REMARKS

This paper responds to the Office Action mailed December 5 2003.

FIG 2 PRIOR ART

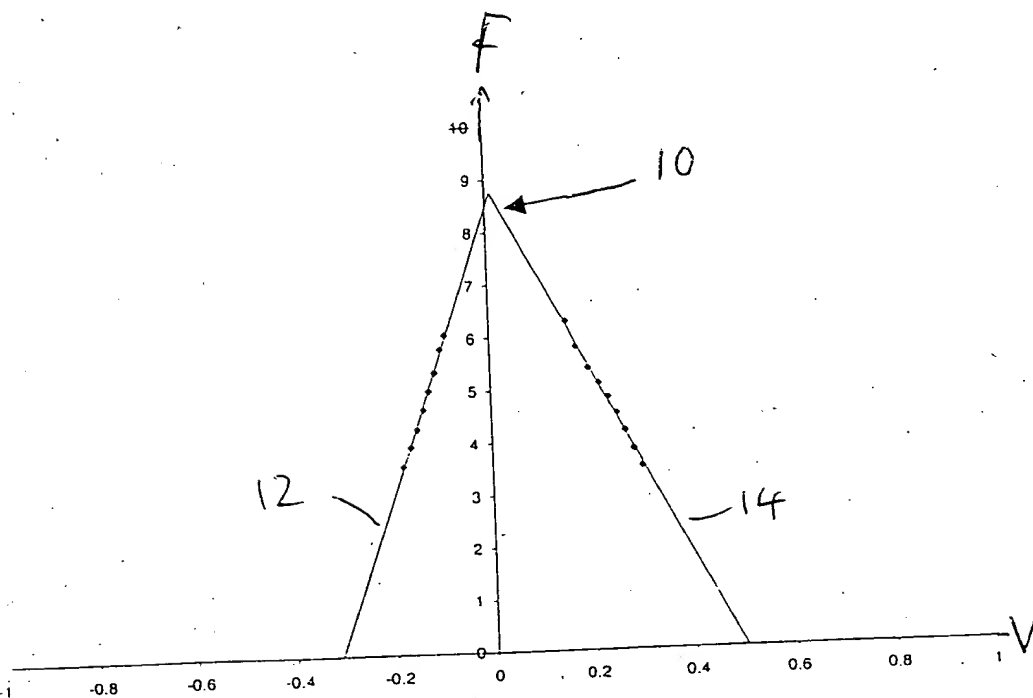
With regard to the objections to the drawings, new pages 1 and 6 of the drawings accompany this response. Figures 1 and 2 are labelled as prior art, and a box "control" has been added to Figure 7 which provides the " V_{VARIABLE} " decision threshold.
